IFB Number: IFB 24-021/KJS

IFB Title: Fleet Maintenance Building

Addendum No.: 3

Reason for Issuance of this addendum: Due date extension, specification changes, plan set changes, and clarification.

PARTIAL MECHANICAL FLOOR PLAN
 SCALE: 1/4"=1'-0" (A)

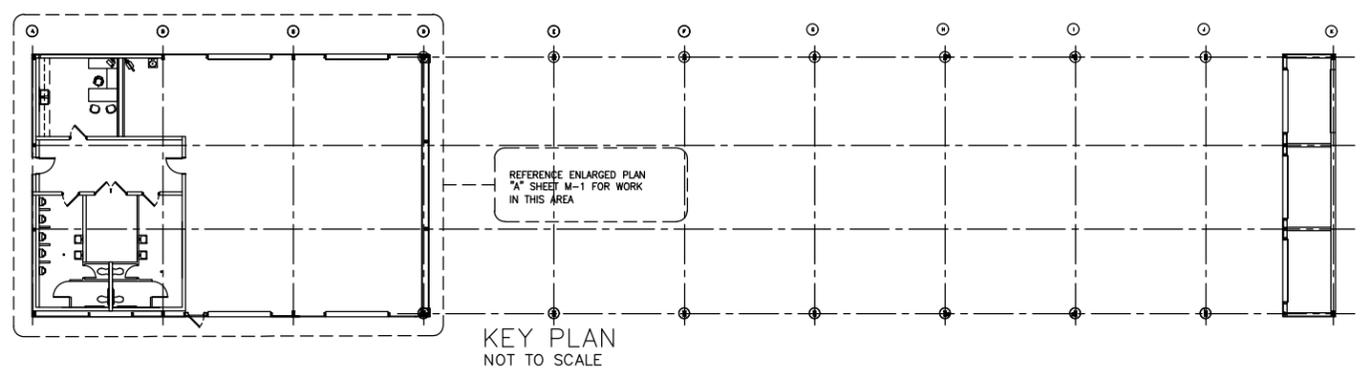
The District is changing the plan set for IFB (24-021/KJS) Fleet Maintenance Building. Updated plan sheets (M1 and M2) are included in Addendum No. 3.

Question 1: The HVAC Mechanical drawings are missing from the issued plan set. Can you provide the drawings?

Answer: The HVAC plans are included with this addendum
